Office of General Services

ADDENDUM NO. 3 TO PROJECT NO. 47007

CONSTRUCTION WORK PROVIDE EXTERIOR RENOVATIONS BUILDING 102 MANHATTAN PSYCHIATRIC CENTER 600 EAST 125TH STREET NEW YORK, NY

June 20, 2025

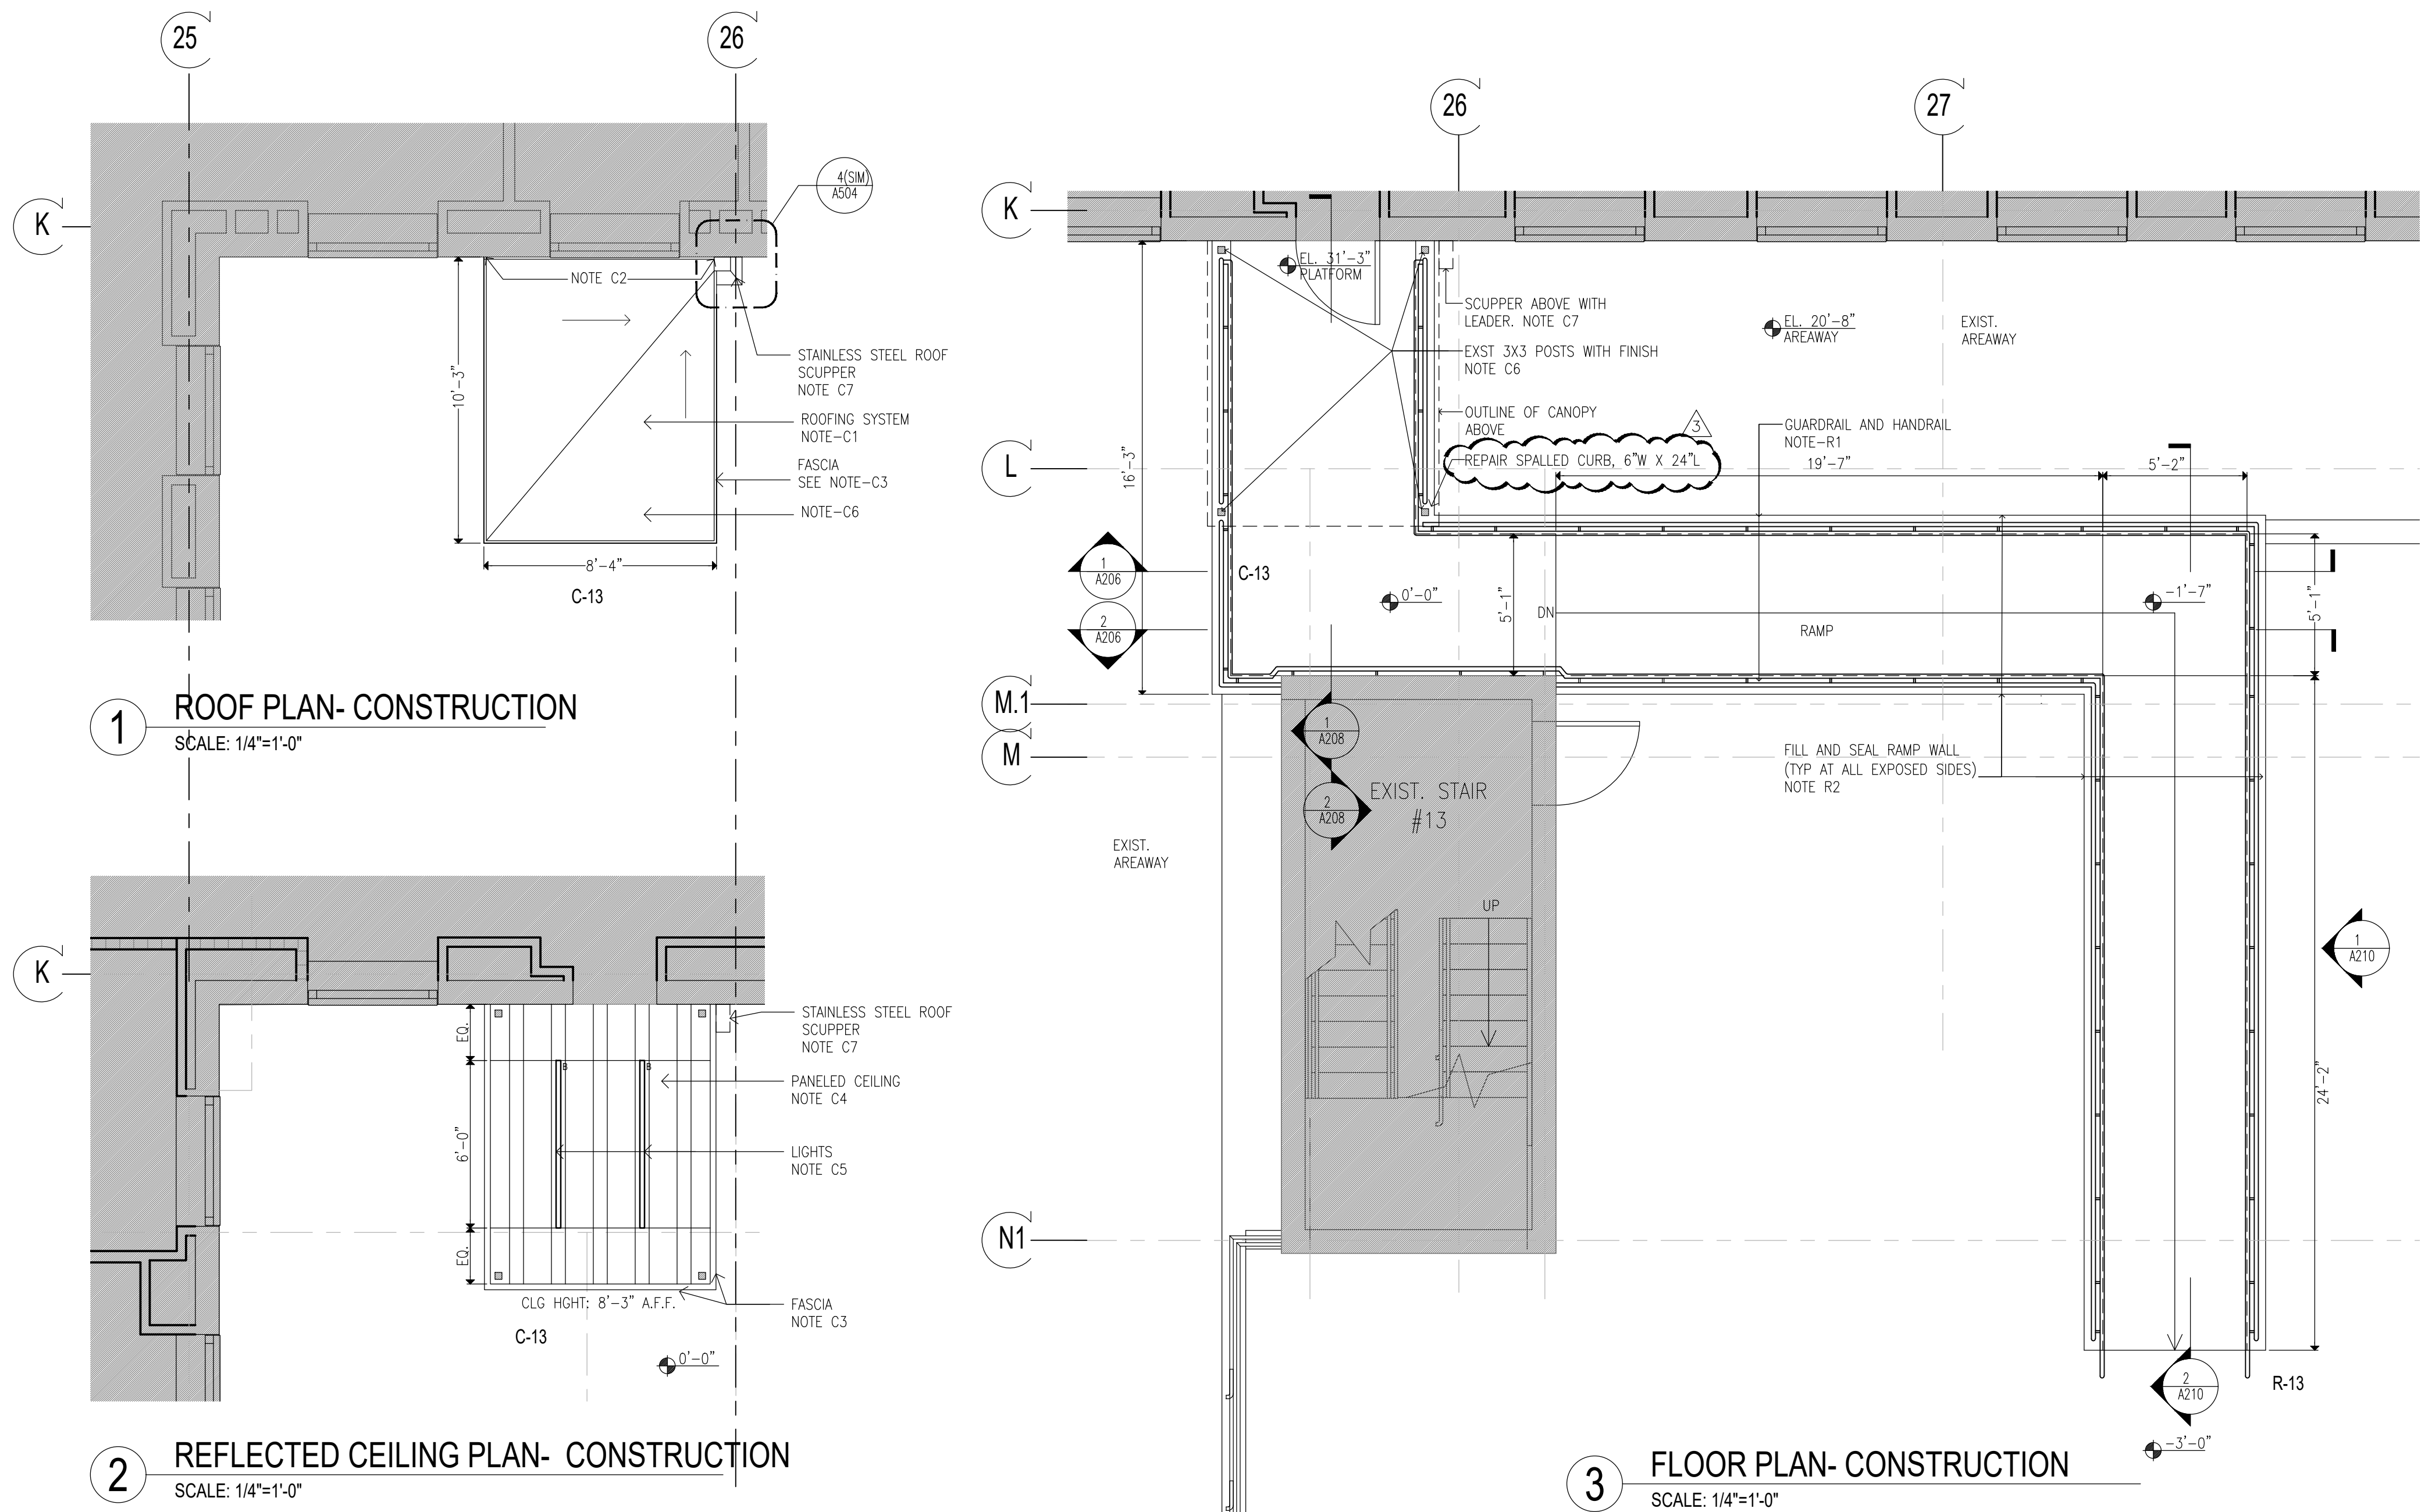
4. Drawing Nos. A-100 and A-200:
 - a. CONSTRUCTION NOTES Column, Change Note S-13 to Read:

“S-13 PROVIDE LAMP POST ('OURO' BY KIM LIGHTING, BASIS OF DESIGN) WITH 6'-0" H, 12" POURED CONCRETE PEDESTAL BASE, SEE DWGS. 1& 2/**A-502**. SEE ELECTRICAL DRAWINGS & SPECIFICATIONS FOR MORE DETAILS, ELECTRICAL DRAWINGS FOR POWER CONNECTION”
